7.6 All Other Instrumentation Systems Required for Safety

The information in this section of the reference ABWR DCD, including all subsections, tables, and figures, is incorporated by reference with the following departures and supplements.

Figure 7.6-4a Basic Configuration of a Typical Neutron Monitoring System Division

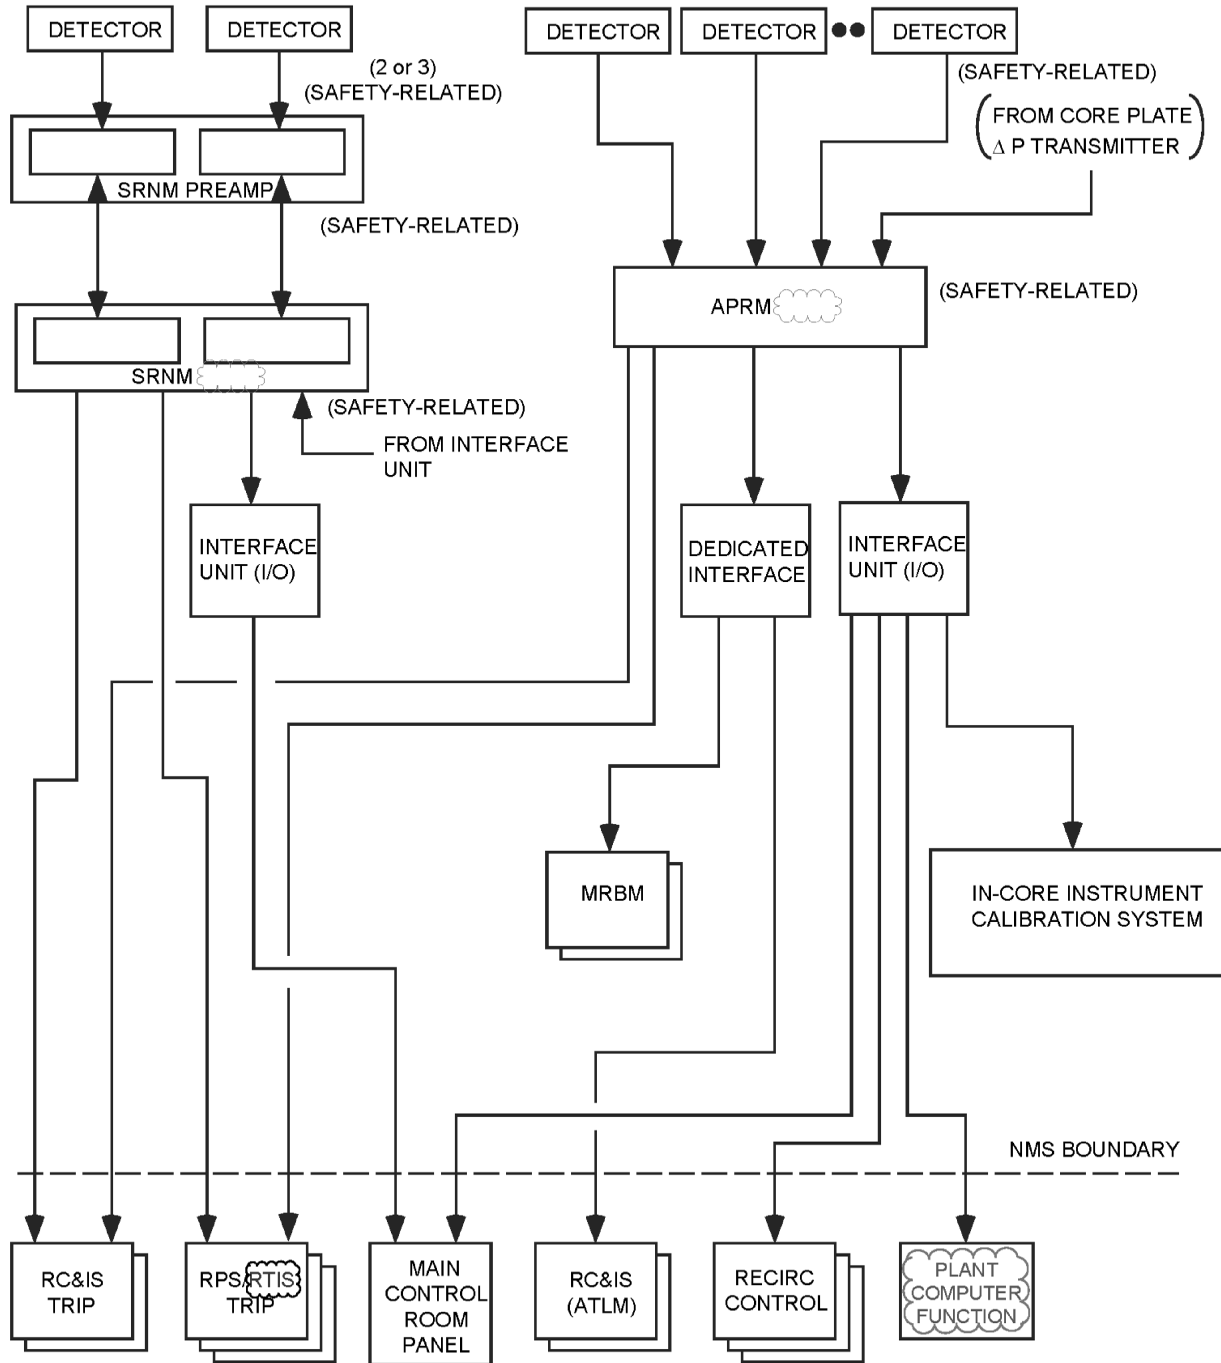
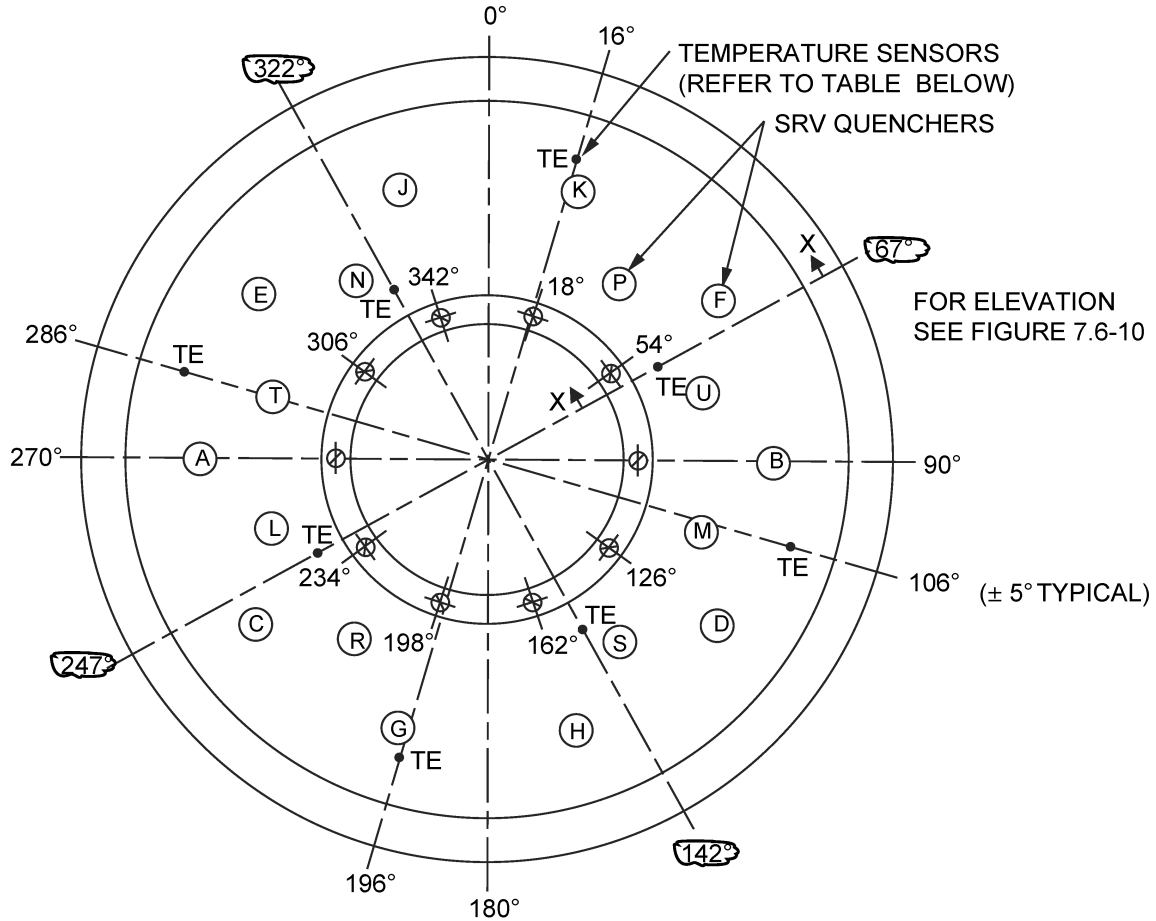
STD DEP T1 3.4-1 (Table 7.6-5 and Figures 7.6-1, 7.6-2, 7.6-4a)

The purpose of the Neutron Monitoring System (NMS) is to monitor power generation and, for the safety function part of the NMS, to provide trip signals to the Reactor Protection System (RPS) to initiate reactor scram under excessive neutron flux (and power) increase condition (high level) or neutron flux fast rising (short period) condition. The NMS also provides power information of operation and control of the reactor to the Plant Process Computer System (PCS) Functions (PCF) and the rod block monitor. A block diagram showing a typical NMS division is shown in Figure 7.6-4a. The operating ranges of the various detectors are shown in Figure 7.6-4b.

Figure 7.6-9 Instrumentation Location Definition for the Suppression Pool Temperature Monitoring System

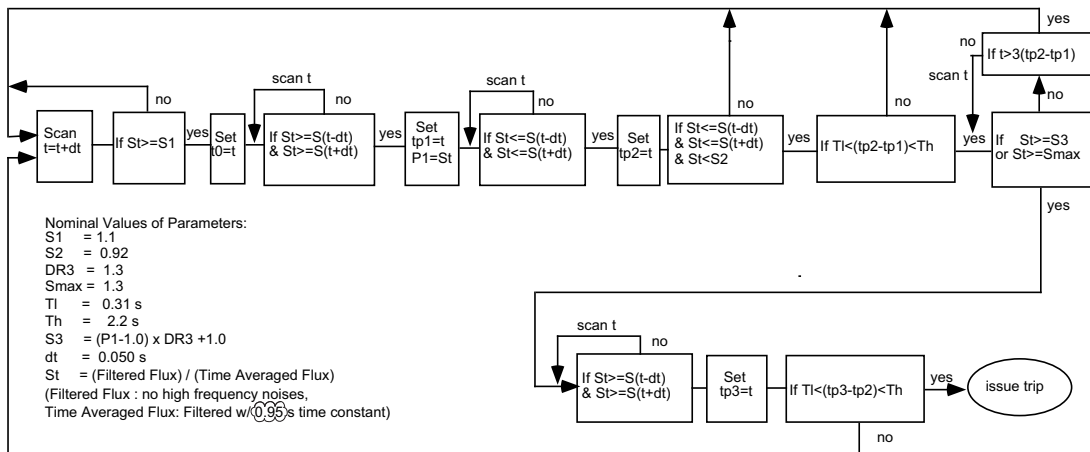
STD DEP 7.6-3 (Figures 7.6-9, 7.6-11)

The SPTM System configuration is shown in Figures 7.6-9 and 7.6-10. There are eight temperature circumferential sensor locations (Figure 7.6-9), which are chosen based upon the following considerations:

- (2) Each SRV discharge line quencher is in direct sight of two sets of temperature sensors within 9 meters.

Figure 7.6-14 OPRM Logic

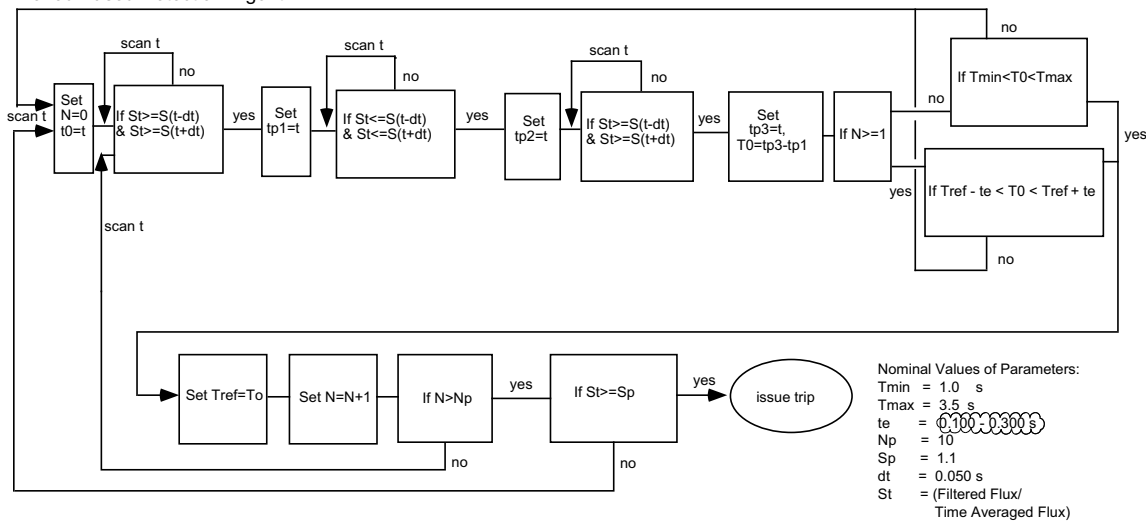
STD DEP 7.6-1 (Table 7.6-2 and Figures 7.6-2, 7.6-14)

For the OPRM trip function, the response signal of any one OPRM cell that satisfies the conditions and criteria of the trip algorithm will cause a trip of the associated OPRM channel. Figure 7.6-14 illustrates the trip algorithm logic. ~~The OPRM trip function does not have its own inoperative trip for insufficient number of total LPRM inputs in the channel. It follows the APRM's inoperative trip of insufficient number of LPRMs.~~ The OPRM function has its own inoperative trip when the channel has less than the required minimum operable cells, when there is an OPRM self-diagnostic fault, when the APRM instrument watchdog timer has timed out, or if there is a loss of power to the APRM instrument.

$T_{\min}=1$ s, $T_{\max}=3.5$ s, $\pm t_{\text{error}}=0.15$ s **[0.100 - 0.300s]**, $N_P=10$.
(For details see Figure 7.6-14).
